Technical Service Bulletin No. 27

Created by: Lab.gruppen AB Service Department

Date: 2011-10-11

Reference no: C12

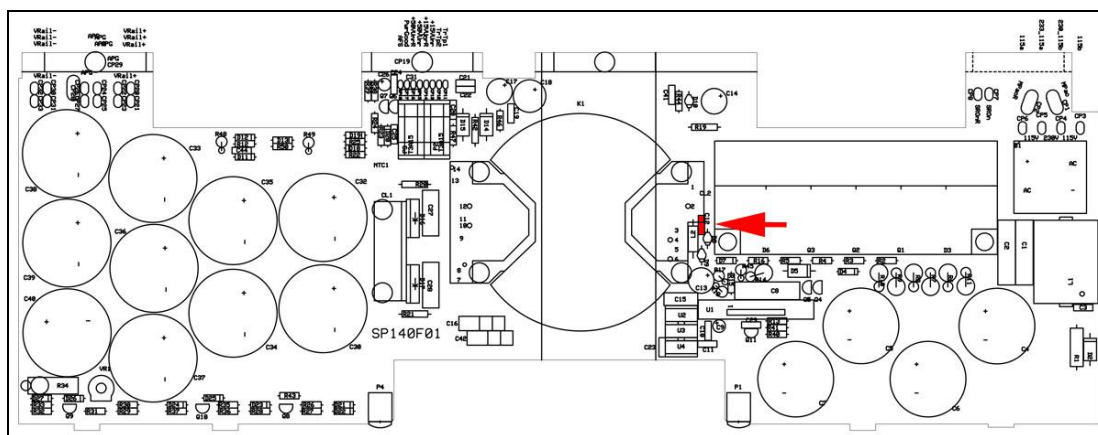
Screaming sound from power supply if amplifier powers up.

Amplifier does not power up.

Replace capacitor C12 with either of below listed components.

Lab Part No.	Description	Amount	Info	Pos
6n8250VMMK5	Wima: FKS2 6800PF 10% 400VDC	1		C12
6n8250VMMK5	Epcos: B32529-C3682-K289	1		C12
